ADDENDUM TO THE CONTRACT

**Bartlett Regional Hospital
MRI & CT Replacement
Contract No. BE23-042**

ADDENDUM NO.: THREE

DATE ADDENDUM ISSUED: August 11, 2022

1
G103
CONTRACTOR STAGING SITE PLAN
1" = 40'-0"

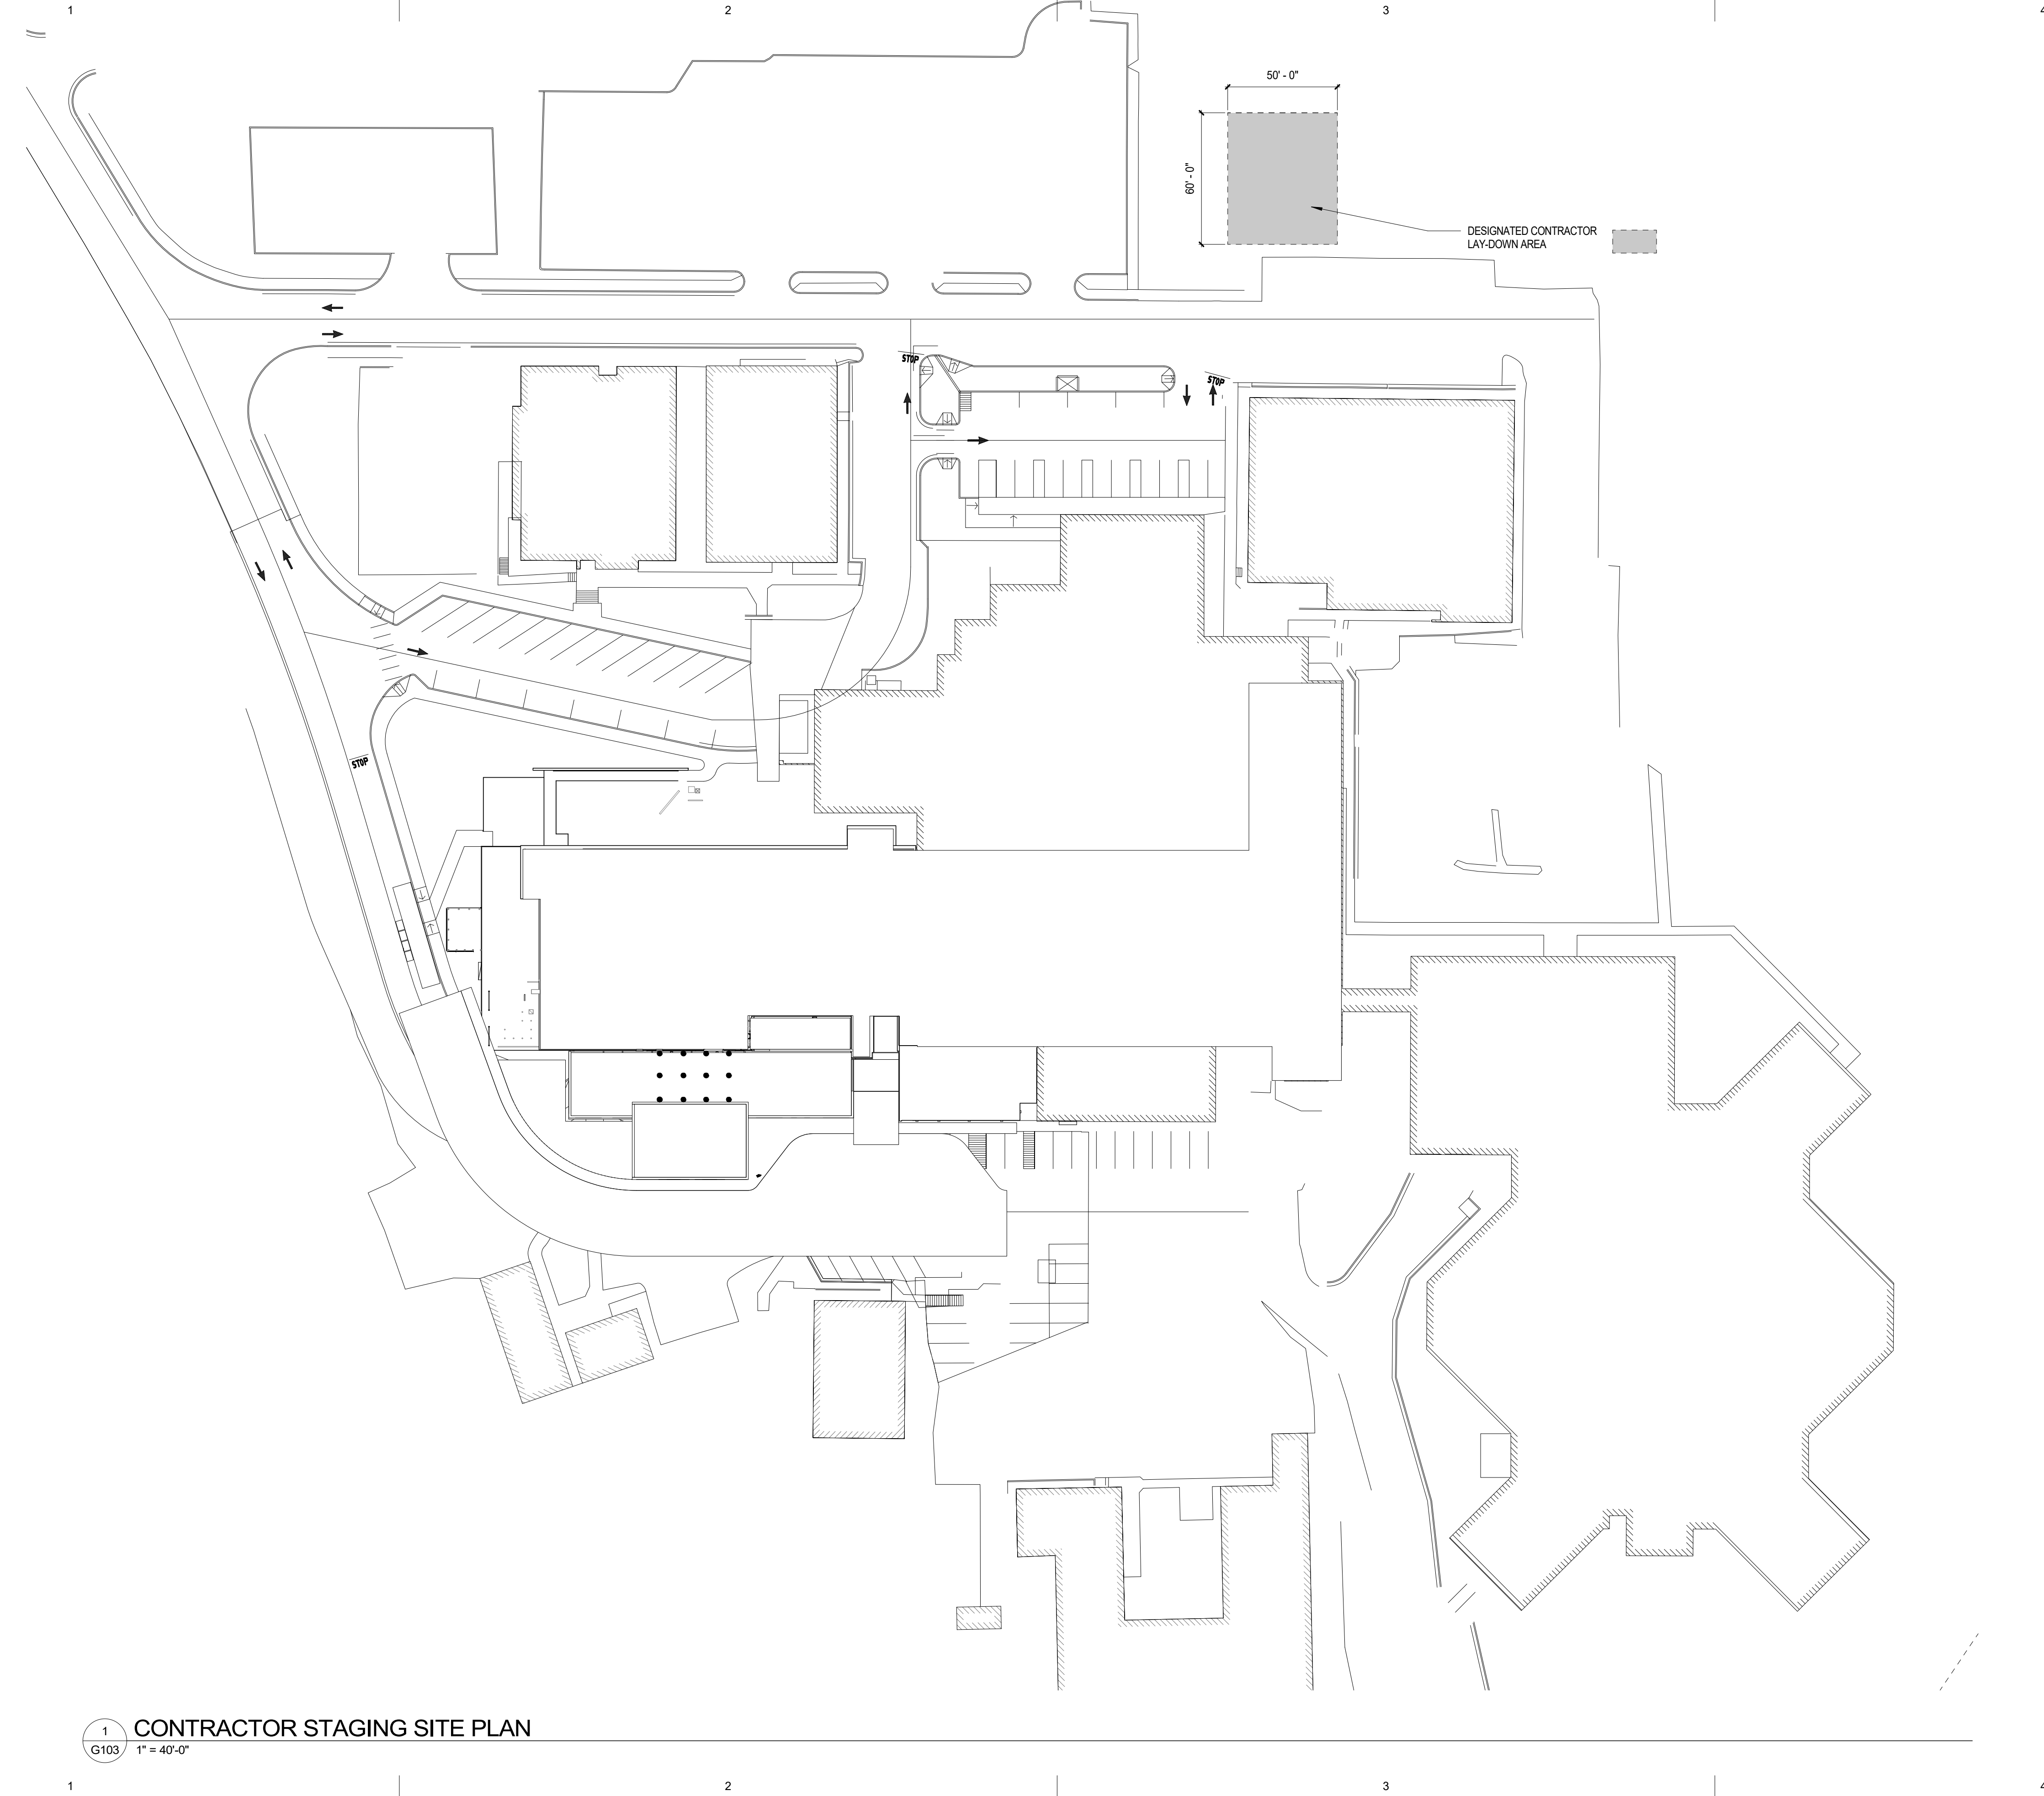
Question: *"Please confirm on-site contractor staging is available, or clarify."*

Response: On-site contractor staging is available for laydown and storage. See added site plan and area marked.

Sheet Title
 SITE PLAN

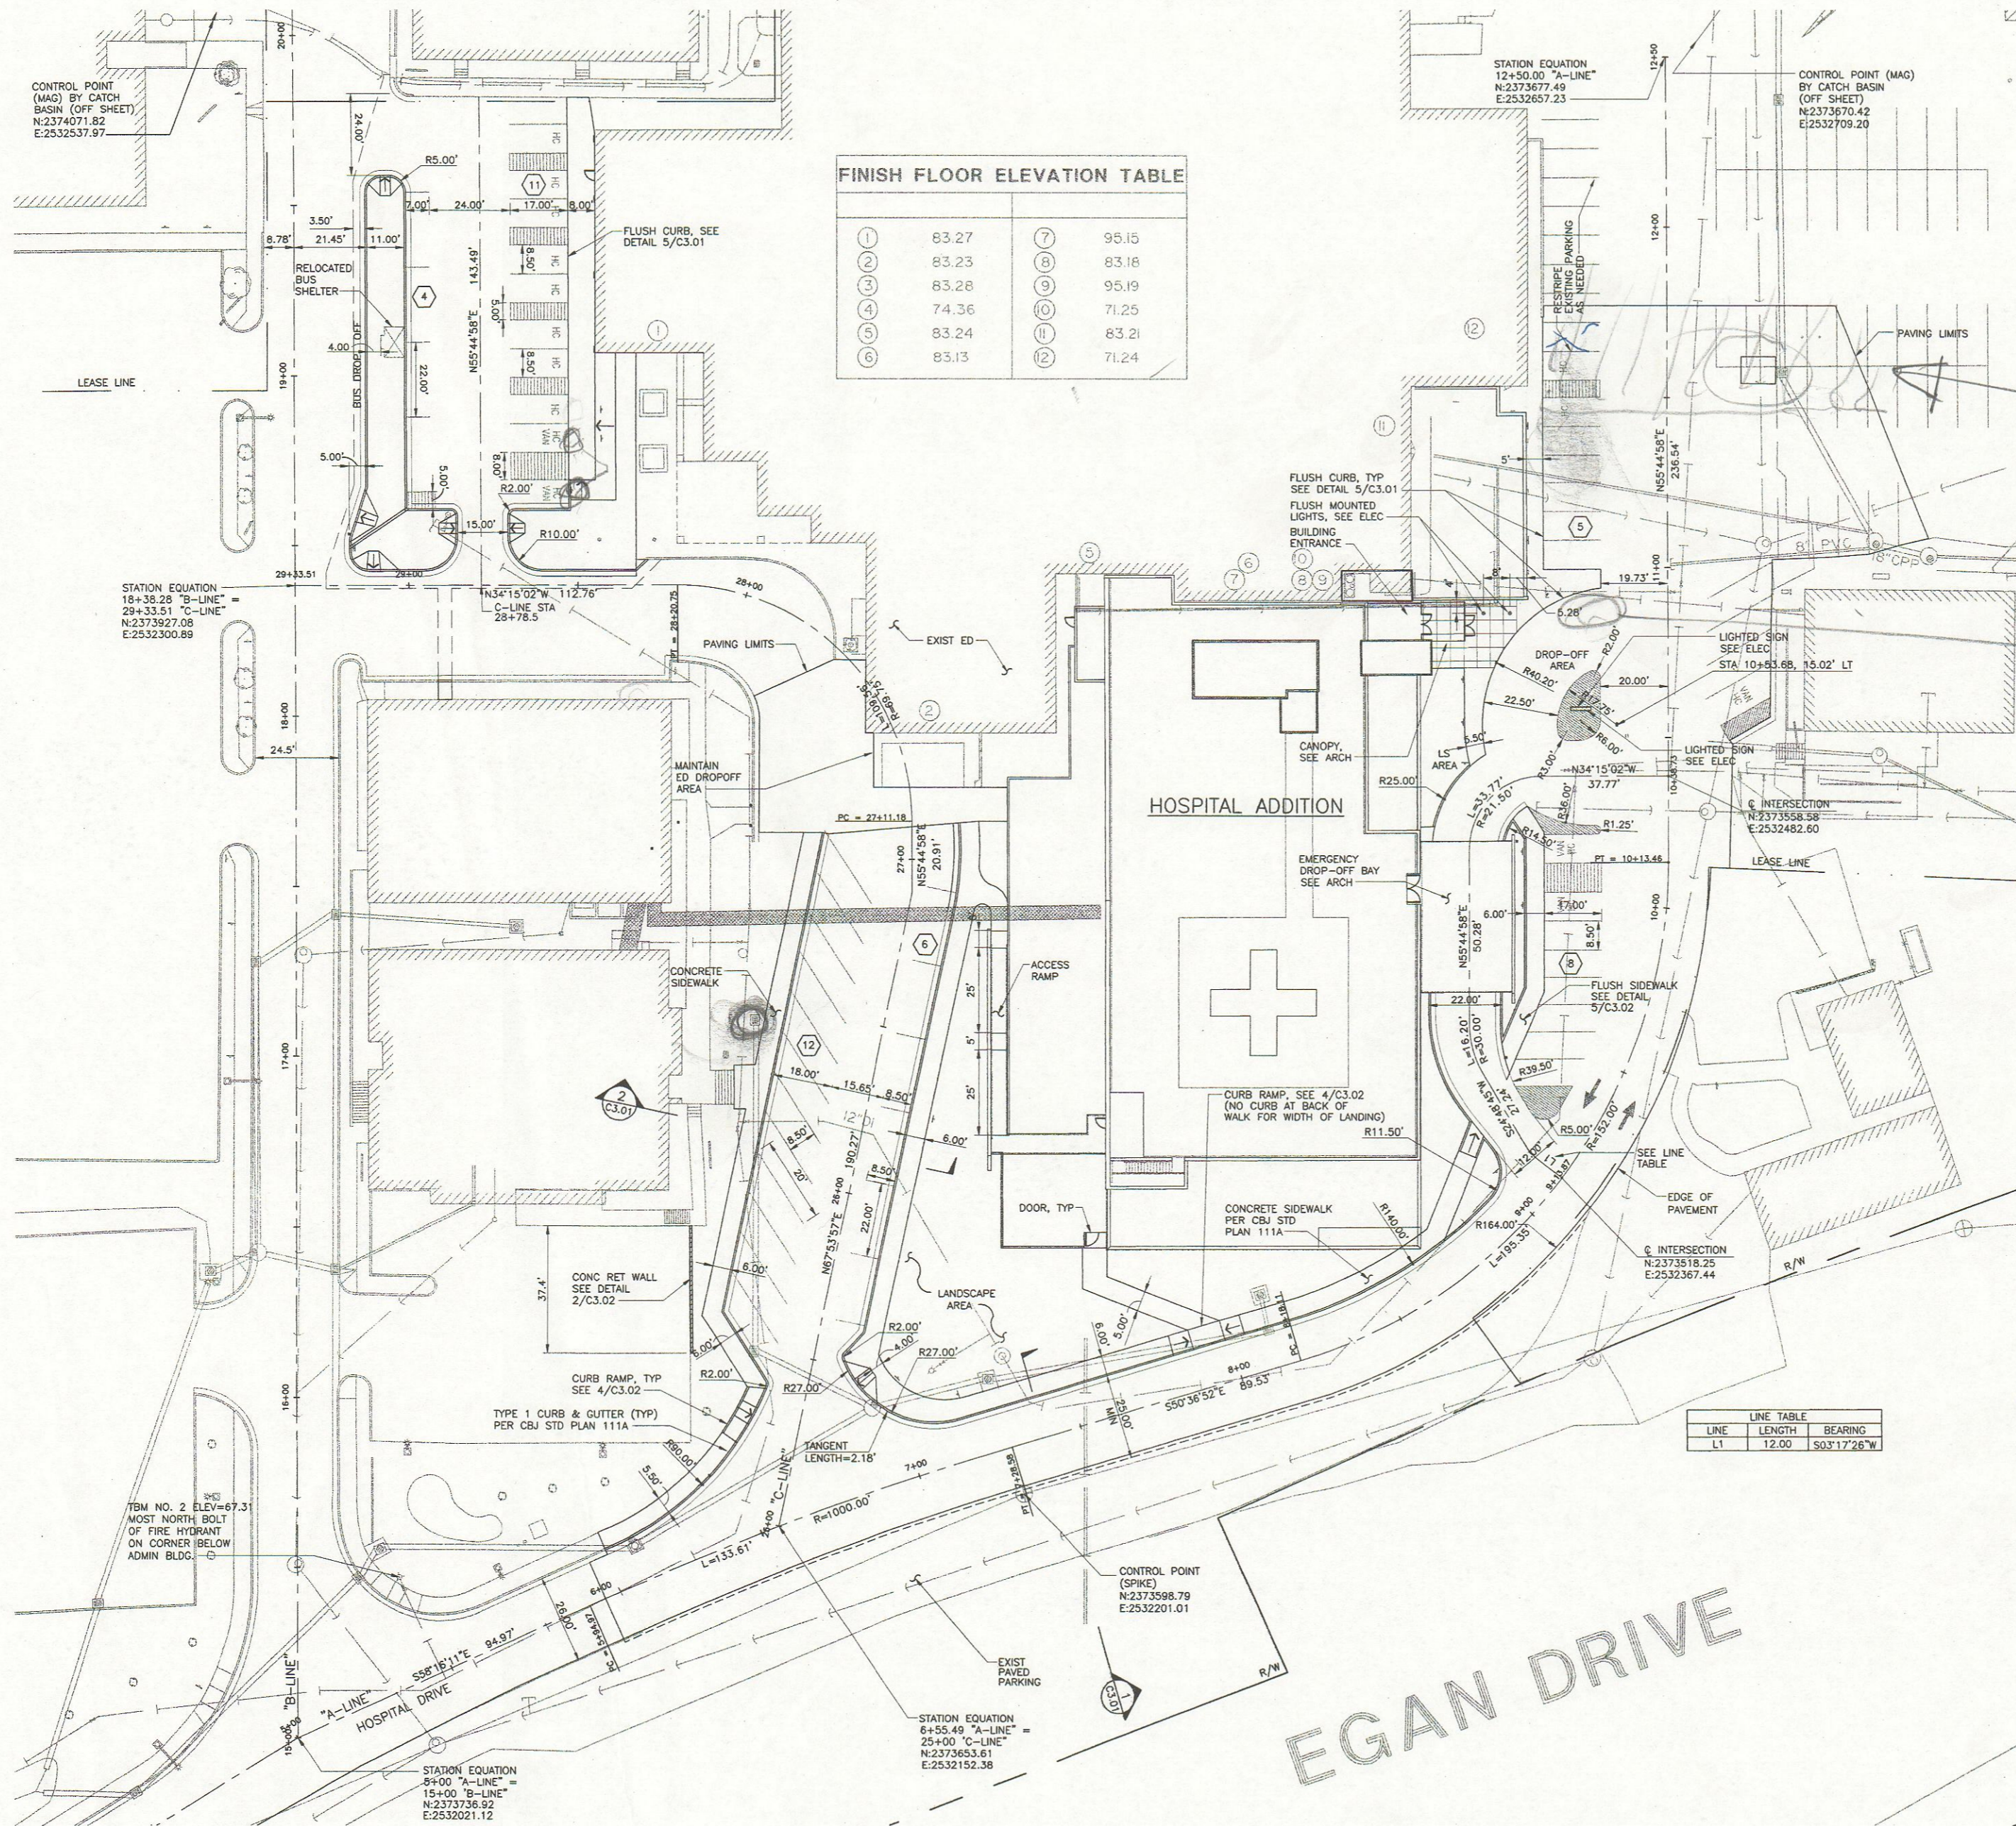
Question: *"Please provide record drawings and/or geotechnical report for area beneath new chiller pad. (C/S102)."*

Response: See attached related 2004 drawings (C1.00, C3.00, and C5.03) to aid in bidding purposes. Call (907) 586-1333 for underground utility locates and 811 Alaska Digline for underground ACS & GCI locates prior to any excavation activities. The contractor is responsible for locating, protecting and maintaining the utilities through the construction of the project. Any damage to the underground utilities during construction shall be paid for by the contractor and shall be considered incidental to the contract.
